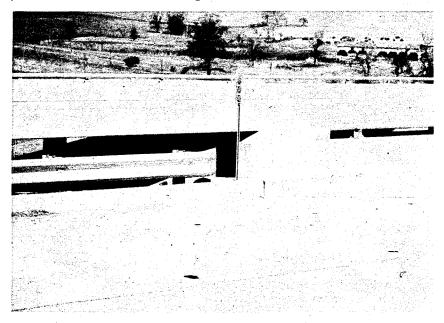
Now here is a closeup. In Missouri's treatment, it doesn't have all of the grooves in it that we found in Indiana; but essentially it is the same massive block of concrete standing between a rail here that is intended to guide traffic along the course up to this point. The rail is about 24 inches here and the top of this is about 27 or 28 inches.

Mr. Constandy. Can we say that it is wrong?
Mr. Prisk. I think it is subject to most of the faults that we have just been discussing.
Mr. Constandy. The same thing basically, is it not?
Mr. Prisk. Yes. The only advantage I see here is the close spacing of the rails, which will offer somewhat more support than we have previously. Otherwise, the same viously. Otherwise, the same.
